10/728,449

William Planey

Office Action Summary

FIGURE 4

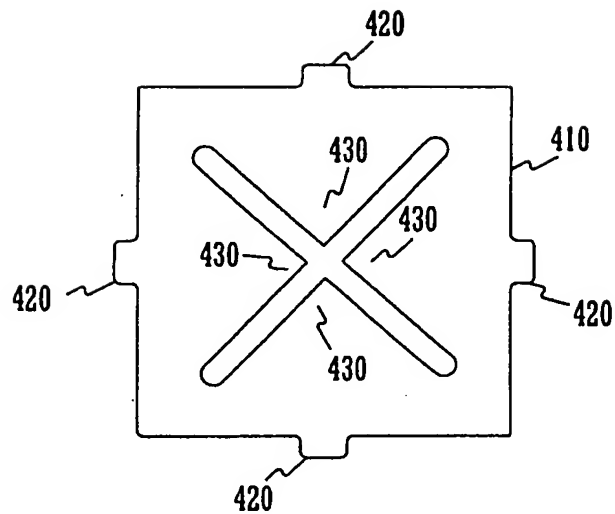
However, figure 4 of Admission illustrates an X-lead frame with four angular tabs 430.

It would have been obvious to one of ordinary skill in the art at the time of the invention was made to replace lead frame 10 of Dunaway with the X-lead frame of the Admission, in order to provide conductive elements for use in interconnecting the lead frame with one of the other electronic device (it is noticed that in col. 5, lines 5 - 10, Dunaway et al. teach that "it is appreciated that lead-frames are variously constructed and shaped").
